# UNITED STATES PATENT AND TRADEMARK OFFICE

APPLICATION NO.	FILING DATE	FIRST NAMED INVENTOR	ATTORNEY DOCKET NO.	CONFIRMATION NO.
10/765,958	01/29/2004	Hiroshi Takeuchi	MIT-024-USA-P	2329
27955	7590	10/02/2006		
TOWNSEND & BANTA c/o PORTFOLIO IP PO BOX 52050 MINNEAPOLIS, MN 55402			EXAMINER REESE, DAVID C	
			ART UNIT 3677	PAPER NUMBER

**Office Action Summary**

### DETAILED ACTION

**FIG. 4**

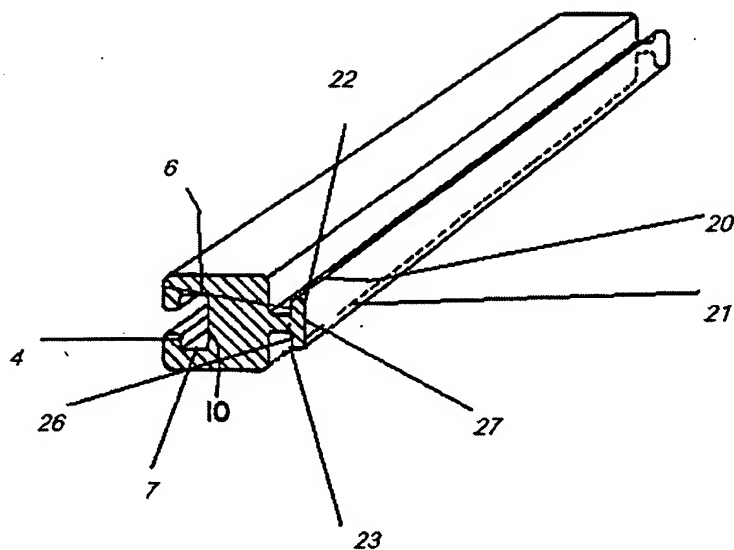
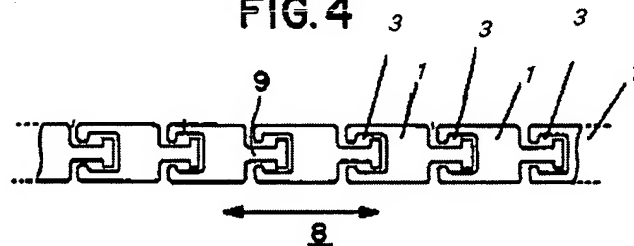
As for Claim 1, SHIRAI teaches of a bendable bottom member of a bed (see figure on page 5 of this office action) comprising a plurality of side by side bars (1) bendably connected with each other to allow the whole extent of the connected bars to be curved (Fig. 2), said bars (1) being disposed generally perpendicular to the longitudinal axis of the bed, one of every adjacent two of the bars (1) is provided with a plurality of longitudinal connecting protrusions (9) being generally parallel to the longitudinal axis of the bed while a plurality of recesses (3) having a rectangular cross-section and right (10) and left (4) lateral walls and top (6) and bottom (7) walls are formed in adjacent bars (1) for accepting protrusions (9) extending from an adjacent bar (1), said protrusions (9) having an approximate rectangular cross-section and faces corresponding in configuration to the walls of said recesses (3) into which the protrusions (9) engage, in such a manner that the connecting protrusions (9) of the bars (1) can be inserted into corresponding recesses (3) of an adjacent bar (1), [whereby] (It has been held that the functional “whereby” statement does not define any structure and accordingly cannot serve to distinguish. *In re Mason*, 114 USPQ 127, 44 CCPA 937 (1957)) motion of adjacent bars (1) in a vertical direction are blocked since top (6) and bottom (7) walls of each of the recesses (3) contact a top (20) and bottom (21) face of a corresponding protrusion (9) inserted therein (Fig. 7A), said protrusions (9) having at tips (26) and bases (27) thereof first (23) and second (22) beveled portions, said firsts (23) beveled portion being formed on a bottom (21) face of each protrusion (9) at its tip (26) and said second (22) beveled portion being formed on a top face (20) of each

protrusion (9) at its back (27), said first (23) and second (22) beveled portions forming clearances between the protrusions (9) and corresponding recesses (3) to allow the connecting bars (1) to be bent a preset distance in one direction only (Fig. 7A), whereby side by side bars (1) can be adjusted in their intervals (each distance between bars can be different due to the diameter of the recess, 3, and also from col. 3, beginning with line 38, "...the bottom structure contain the bottom strips can be bent and also adjusted in length in the longitudinal direction of the bed") and can be rotated in one direction up to a predetermined angle, and disengagement preventing (ends of 9) means comprising hooks (end of 9) formed at a tip of some of the connecting protrusions (9), and corresponding accepting recesses (3) having steps (12) therein adapted to engage the hooks (end of 9), so that the hooks (end of 9) and steps (12) are engaged with each other when the respective adjacent bars are kept furthest away from each other (Fig. 7A), whereby bars (1) arranged side by side can be adjusted in gaps between adjacent bars (col. 3, beginning with line 38, "...the bottom structure contain the bottom strips can be bent and also adjusted in length in the longitudinal direction of the bed"), said bars (1) being connected with each other in such a manner that they can be curved as a whole up to a limited predetermined angle in one direction only (Figs. 2, 7A).

Re: Claim 2, wherein a bar (1) disposed at an end of the bendable bottom member on one side has only accepting recesses (3).

Re: Claim 3, wherein first beveled portions (23) are formed on lower sides (21-bottom) at the tips (26) of the connecting protrusions (9) while second beveled portions (22) are formed on the upper sides (20-top) at the bases (11) of protrusions (9), to use the bendable bottom member as a bendable portion between the back region and the waist region.

Re: claim 5, wherein the second beveled portions (22) at the bases (27) of the connecting protrusions (9) are inclined in adaptation to the desired bending angles with the adjacent bars (1) (Fig. 7A) (see figure below).

Re: Claim 6, wherein hooks (end of 9) formed at tips of connecting protrusions (9) are provided with the disengagement preventing means (inside 12) while steps (12) to be engaged with the hooks (end of 9) are formed in the corresponding accepting recesses (3).

Re: Claim 7, wherein the second beveled portions (22) at the bases (27) of the connecting protrusions (9) are inclined in adaptation to the desired bending angles with the adjacent bars (1) (Fig. 7A).

Re: Claim 8, wherein the second beveled portions (22) at the bases (27) of the connecting protrusions (9) are inclined in adaptation to the desired bending angles with the adjacent bars (1) (Fig. 7A), and a gap being formed between every adjacent two connecting protrusions (9).
